COUNTY OF SAN MATEO
Parks Department

TO: Parks and Recreation Commission
FROM: Carla Schoof, Community Programs Specialist
SUBJECT: Flood County Park Preferred Alternative Landscape Plan

Review and approve the Preferred Alternative Landscape Plan for Flood County Park in concept and direct staff to proceed with assessment of the potential impacts that the proposed plan may have on noise, traffic and parking.

Flood Park Preferred Plan

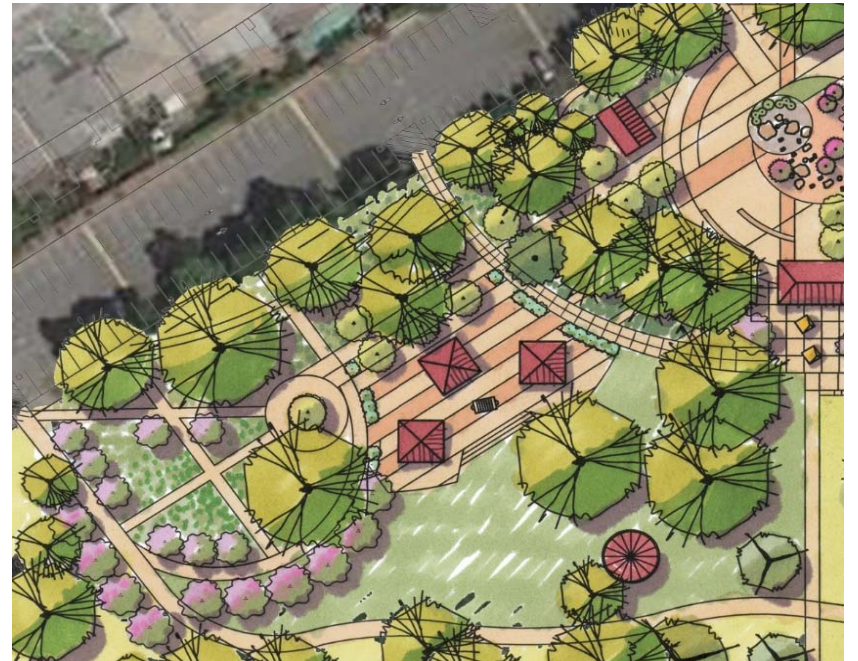
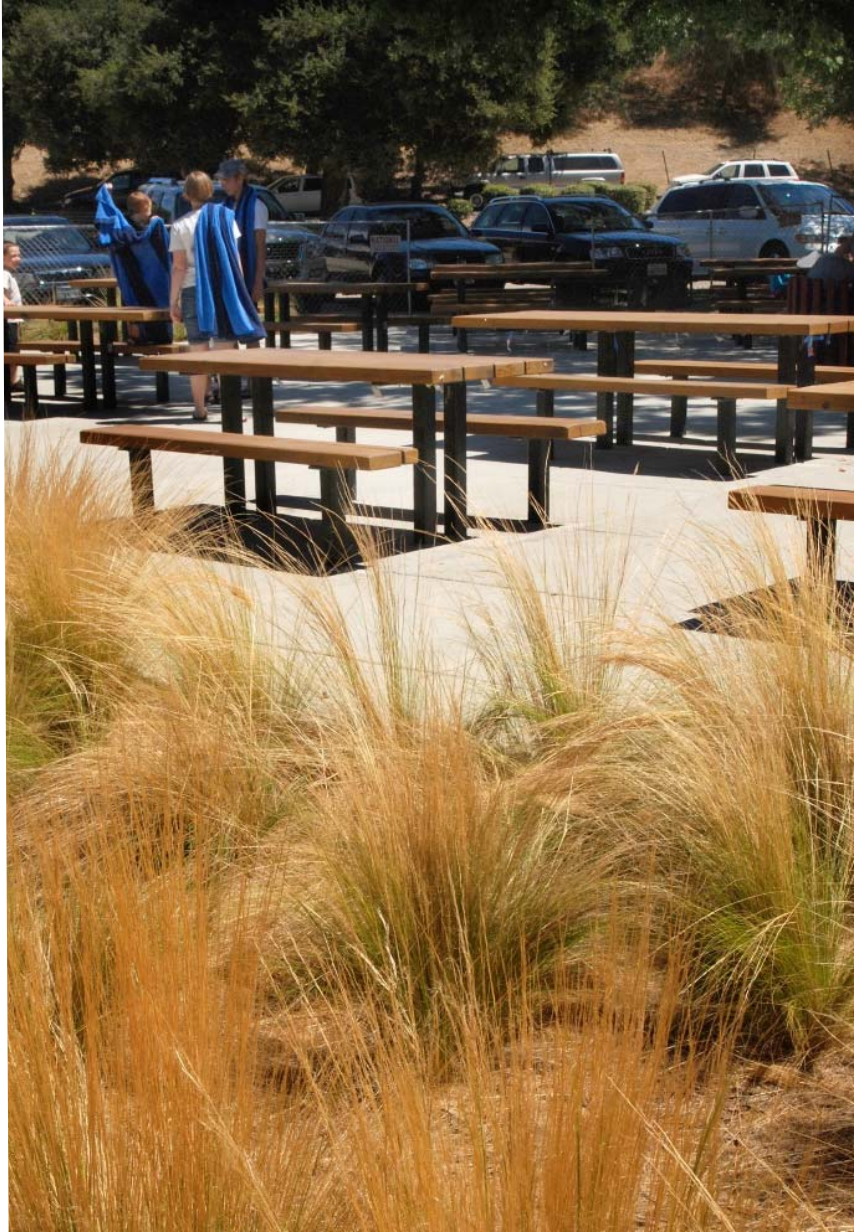
- 1) Why was there not a multipurpose field in the "Preferred Plan" instead of the two big sports fields? David Gates said this was not possible in at least one community meeting yet we have discovered multi-use fields are common and becoming a preferred field choice in many situations. I sent you information on multi-use fields in a prior email.

- 2) Is a multipurpose field being designed now as a possible alternative to the two fields? There will likely be many fewer trees sacrificed (if any) if designing a multi-use field in the space of the existing ball field space. Your current "preferred plan" is sacrificing Redwood trees for Oak trees.

- 3) Why is a full-size field wanted? (A youth soccer field was proposed in the meetings in September). Since lacrosse fields are larger than soccer fields, how much demand in our community is there for a lacrosse field? Lacrosse is included in the "Preferred Plan" presented in December, but was not in the September community meeting.

- 4) What was meant when the landscape designer, Mr. David Gates, said the neighbors would be "buffered" from noise of park activities? Most local soccer fields do not have houses adjacent to them. What is planned to "buffer" neighbors along Del Norte Avenue, Iris Lane, and Haven House from park noise from the sports areas? What is planned to prevent balls from landing in neighbors' yards?

- 6) One of the two volleyball courts in the "Preferred Plan" is located very near the adjacent neighbors. The spectator risers are even closer. Volleyball games currently occur every afternoon and can be noisy. These courts should be moved toward the center of the park.

c) The exciting new "Adventure Play" area, # 8 on the "Preferred Plan," is not right next to the other play areas (#7). It should be next to them for safety reasons so parents will be able to see kids of different ages in all 3 play areas at once.

a) In the "Preferred Plan," the jogging/biking trail goes all the way around the soccer field which could enable youths to be way out of sight of their parents. This would be a safety concern. Currently, the trails can be seen from most places in the park.

b) The new plan has the trail cutting through the interior of the redwood/bay/buckeye grove in the Bay Road corner of the park. This is a peaceful, undeveloped area. A church group brings chairs and meets there all day on many Sundays during good weather. Putting the trail through it would mean that the church group couldn't use that area and that there would be no undeveloped natural retreat area in the park.

5) Volleyball courts: 2 is not enough. There are currently 4 courts and they are frequently used. Also, the "Preferred Plan" has the new location of the courts too close to neighbors. Volleyball is noisy.

10) Online information: Please provide a larger diagram of the proposed plan that shows details such as many of the family/drop-in picnic tables which are not visible in the current "Preferred Plan." Are they are not included in the new plan?

As we discussed earlier, the preferred plan reflects the priorities identified through the community engagement process. It does not reflect final or detailed elements of each feature, such as location of all picnic tables. The points you raise will be reviewed as we continue to work through our planning process.
